ZONING BOARD OF ADJUSTMENT, PANEL C
MONDAY, SEPTEMBER 15, 2014
AGENDA

BDA 134-079	2662 Sutton Street REQUEST: Application of Harvey Wright for a variance to the front yard setback regulations	1
BDA 134-089	3706 Duchess Trail REQUEST: Application of John L. Bourret, represented by Amy J. Bourret, for a special exception to the fence height regulations	2

BDA 134-059	2114 Clements Street REQUEST: Application of John Moncure Henderson, IV for variances to the front and side yard setback regulations, and a variance to the off-street parking regulations	3
--------------------	---	---

BOA Drawing A3 for Setback Variance
2662 Sutton, Dallas, Texas

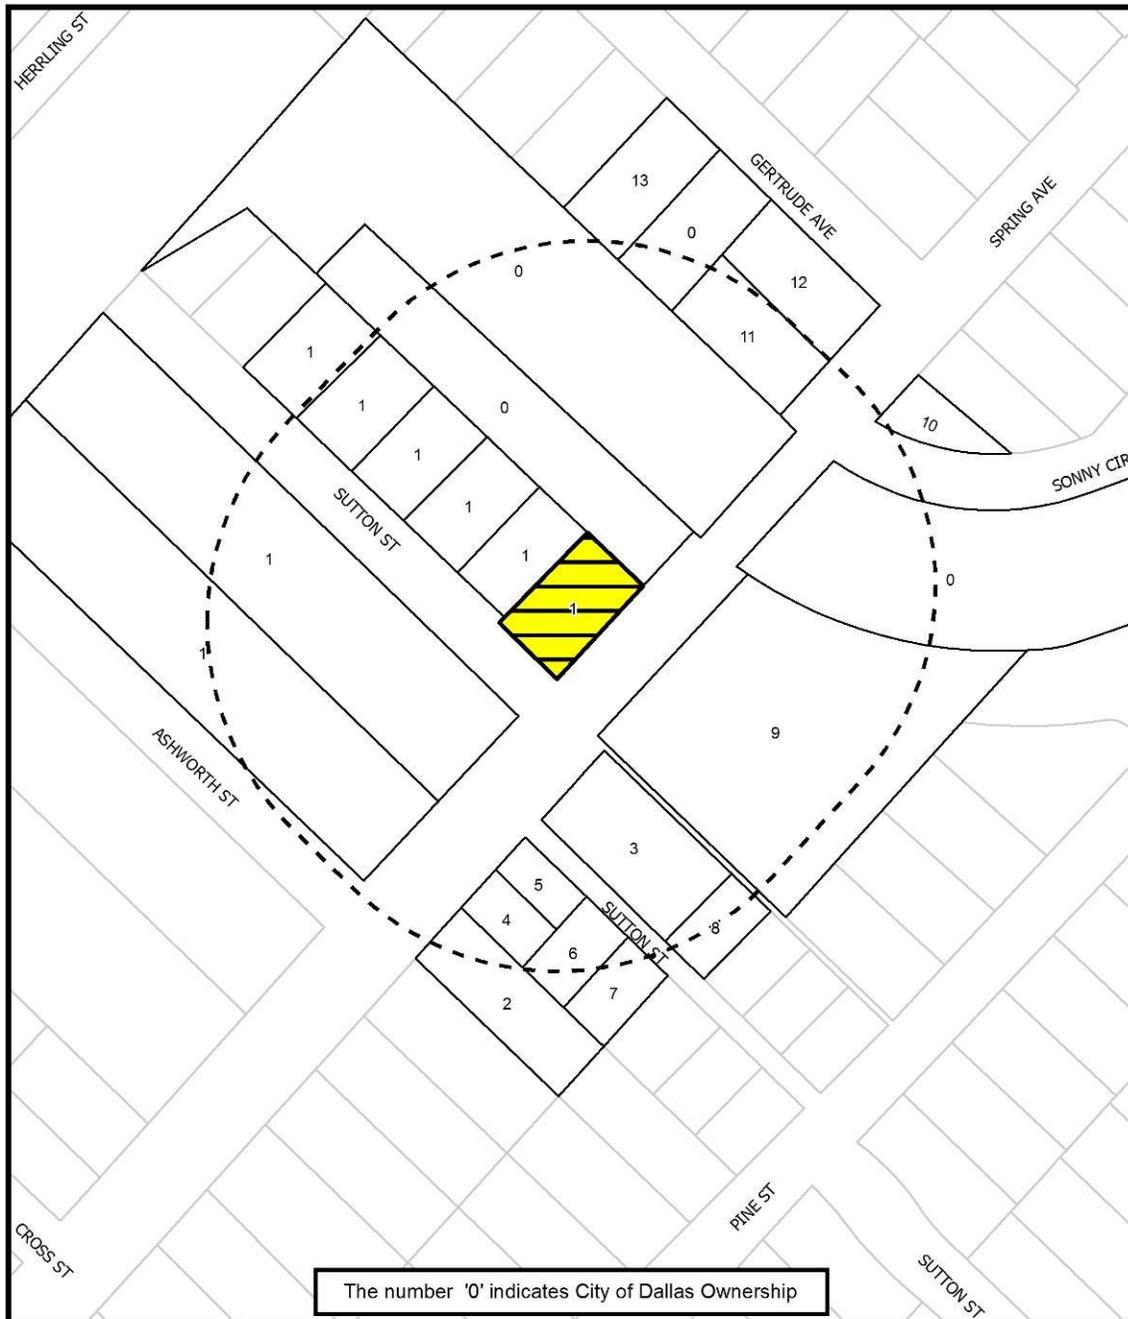
- A scaled site plan has been submitted indicating that a portion of a porch structure and a ramp structure attached to the single family home on the subject site is located as 11’ from the Sutton Street front property line or 9’ into this 20’ front yard setback. The submitted site plan indicates a portion of the single family home structure is located 15’ 3” from the Spring Street front property line or 4’ 9” into this 20’ front yard setback.

- According to calculations taken by the Board Administrator from the submitted site plan, approximately half of the approximately 200 square foot porch structure and the entire approximately 50 square foot ramp structure is located in the site’s 20’ Sutton Street front yard setback; and that approximately 200 square feet (or approximately 16 percent) of the approximately 1,200 square foot single family home is located in the Spring Street front yard setback.

- If the Board were to grant the variance requests, and impose the submitted site plan as a condition, the structures in the front yard setbacks would be limited to what is shown on this document— which in this case are structures located as close as 11' from the Sutton Street front property line (or 9' into this 20' front yard setback) and 15' 3" from the Spring Street front property line (or 4' 9" into this 20' front yard setback).

SKETCH A
Front side of fence: 2 x 4 Cedar rails; Board-on-Board with 6" pattern;
4" / 2" flat trim on top; treated base board

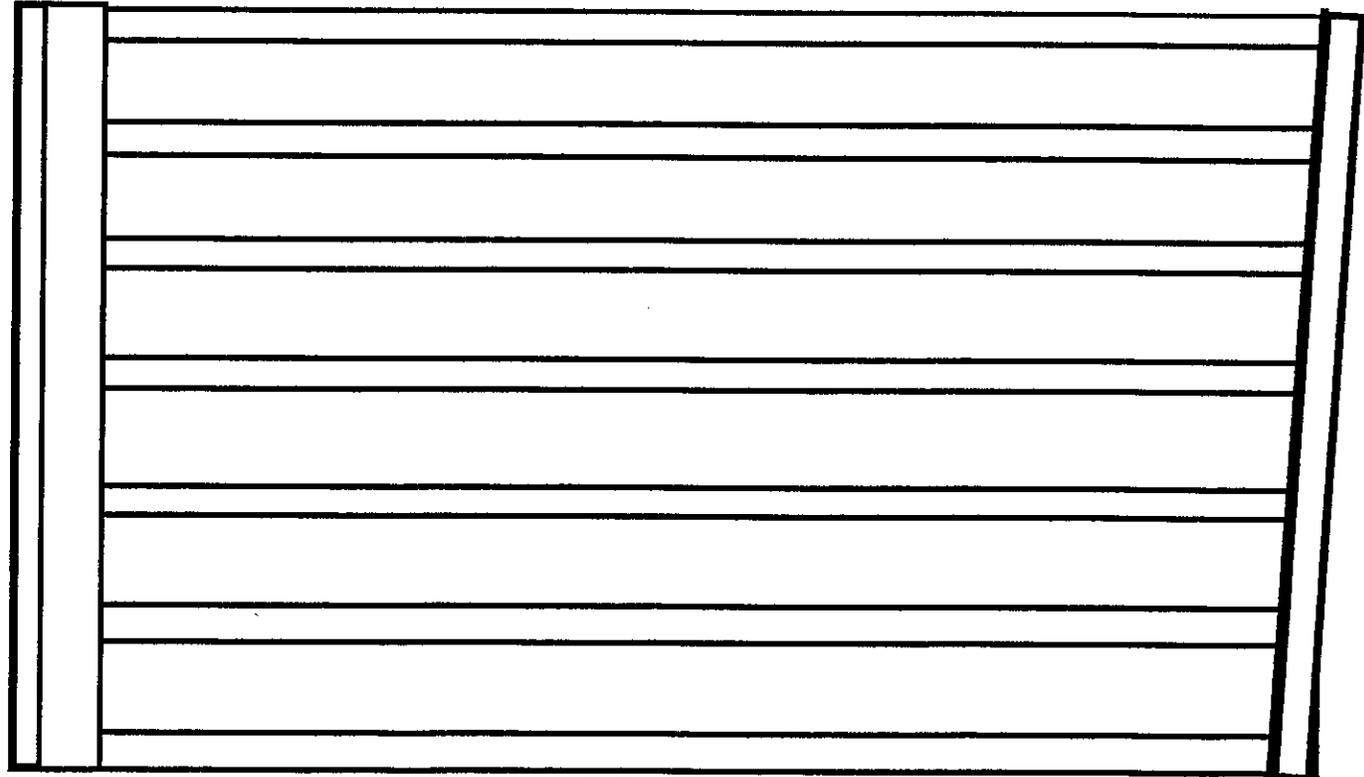
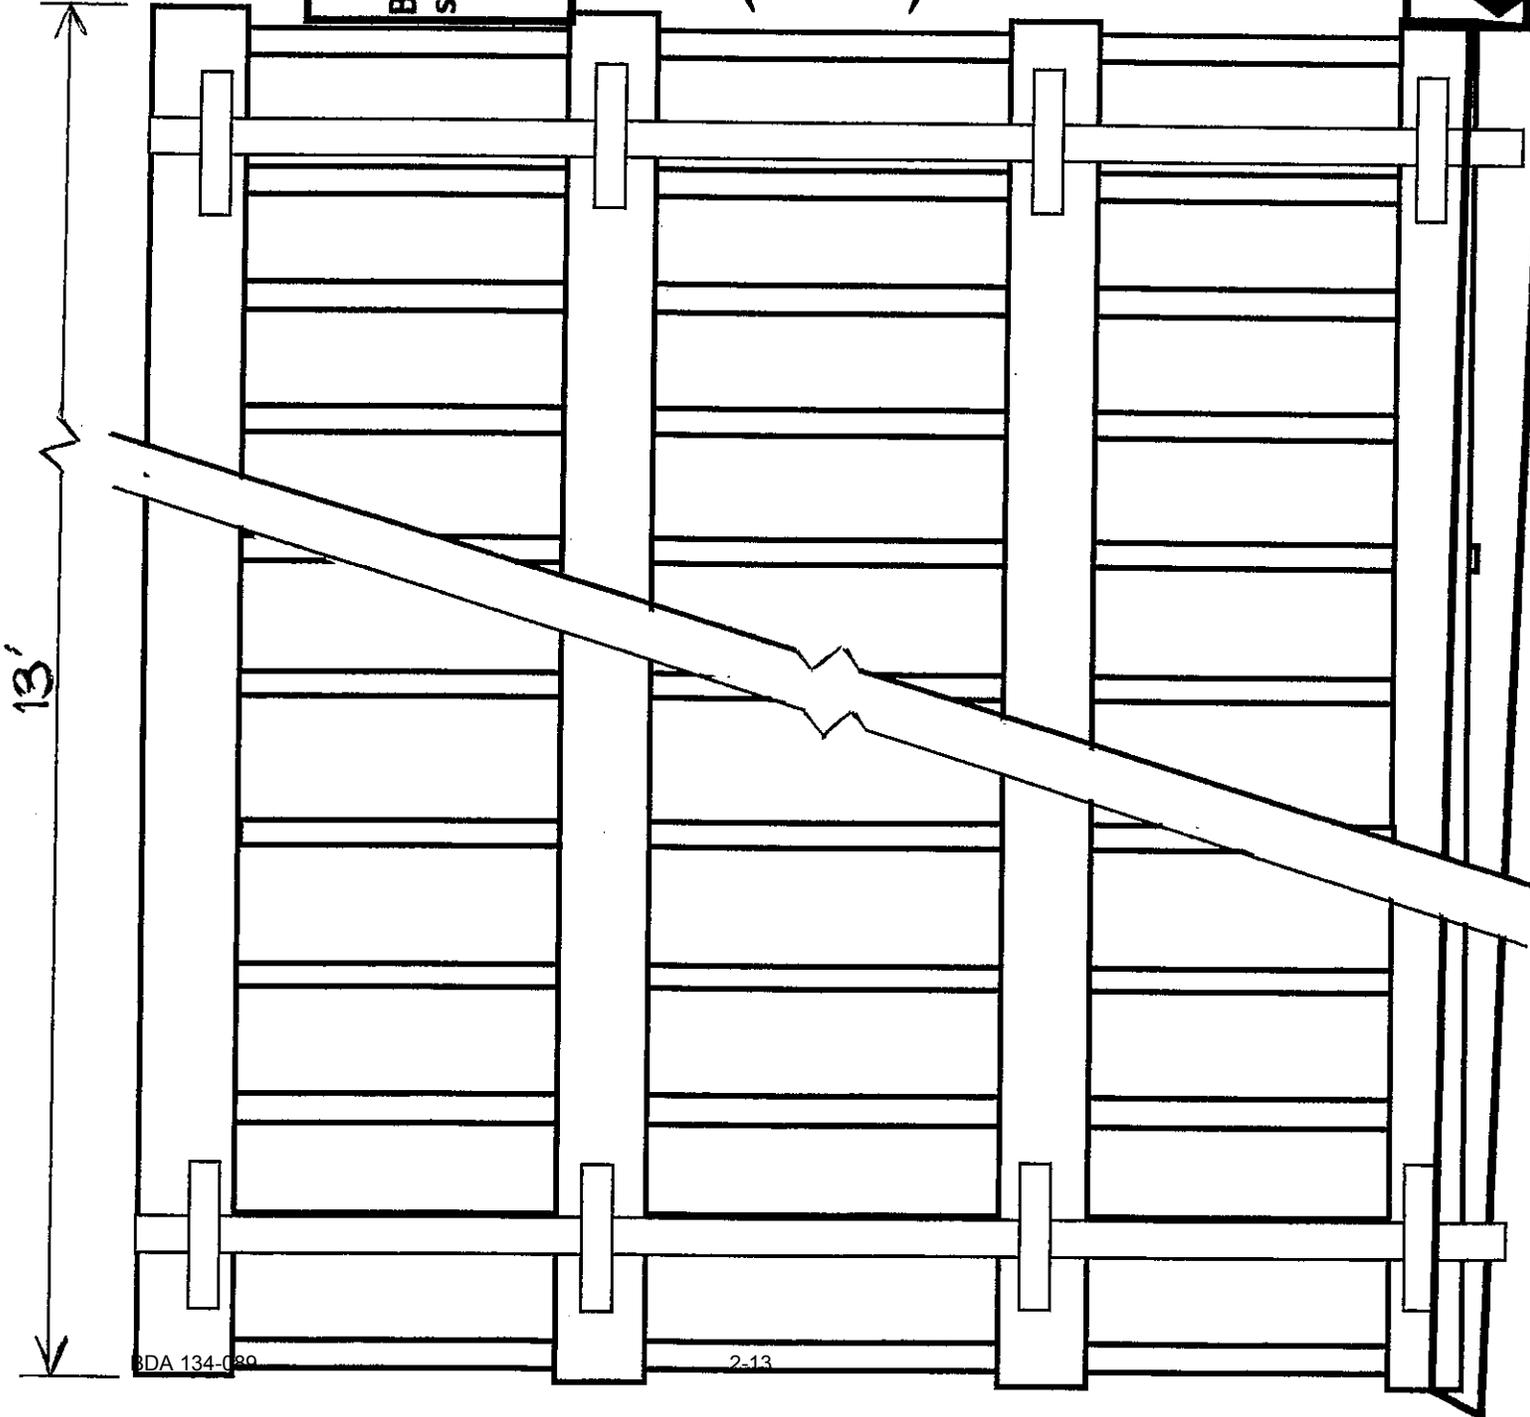
- The applicant has submitted a site plan and elevations of the proposal in the front yard setback with notations indicating that the fence reaches a maximum height of 9'.

- The following additional information was gleaned from the submitted site plan:
 - The proposal is represented as being approximately 85' in length parallel to the Marsh Lane and approximately 13' perpendicular to Marsh Lane on the north and south sides of the site in this front yard setback.

- Granting this special exception of 5' with a condition imposed that the applicant complies with the submitted site plan and elevations would require the proposal exceeding 4' in height in the Marsh Lane required front yard to be maintained in the location and of the heights and materials as shown on these documents.

1 PROPOSED NEW BUILDING FOUNDATION FOOTPRINT & ROOF OUTLINE
1/8" TO 1"

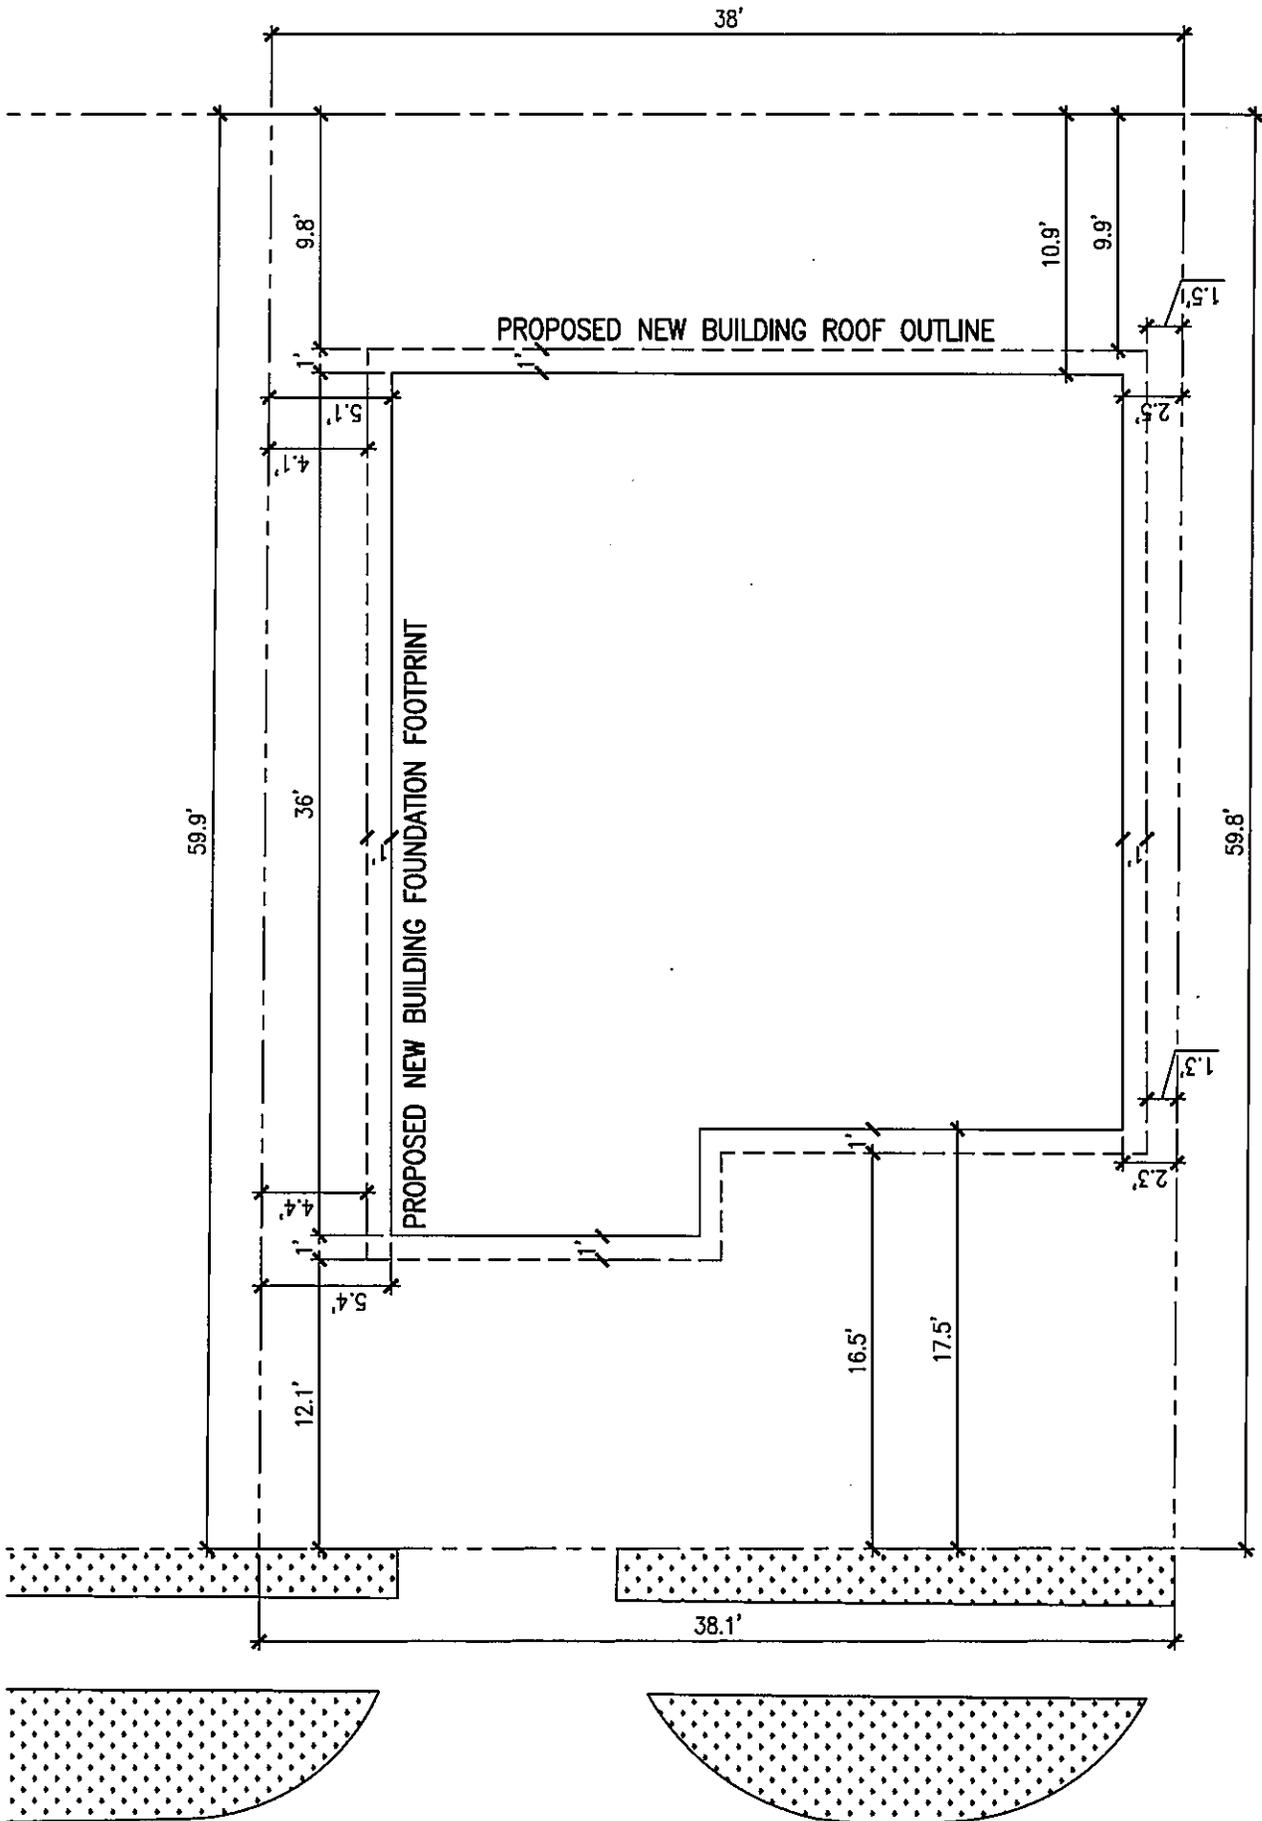
- Structures on lots zoned R-7.5(A) are required to provide a minimum front yard setback of 25'.
- The applicant had submitted a site plan that showed a structure located 12' from the front property line or 13' into the 25' front yard setback.

- According to calculations taken from the submitted site plan by the Board Administrator, approximately 275 square feet (or 25 percent) of the total approximately 1,025 square foot building footprint was to be located in the 25' front yard setback.

- Structures on lots zoned R-7.5(A) are required to provide a minimum side yard setback of 5’.
- The applicant had submitted a site plan that shows the proposed structure and roof eaves located as close as 1’ 3” from the site’s southern side property line or 3’ 9” into this required 5 side yard setback.

- According to calculations taken from the submitted site plan by the Board Administrator, approximately 110 square feet (or 11 percent) of the total approximately 1,025 square foot building footprint is to be located in the southern 5’ side yard setback.

- The submitted site plan and 1st floor plan had denoted the location of an enclosed parking space in the proposed structure 13.1’ from the Clements Street street right-of-way line or approximately 31’ from the projected pavement line.

- The Sustainable Development and Construction Department Project Engineer had submitted a review comment sheet regarding the applicant’s request marked “Has no objections if certain conditions are met” commenting “subject to provide 15’ of clearance between the face of the proposed garage and the property line instead of

13.1 feet as shown on the site plan.” But at the June 23rd briefing, he informed the Board at the briefing that he no longer felt that imposing the condition that a 15’ clearance between the face of the proposed garage and the property line must be provided and maintained was necessary as long as the Board imposed the condition that at no time may the area in front of the garage be utilized for parking of vehicles.
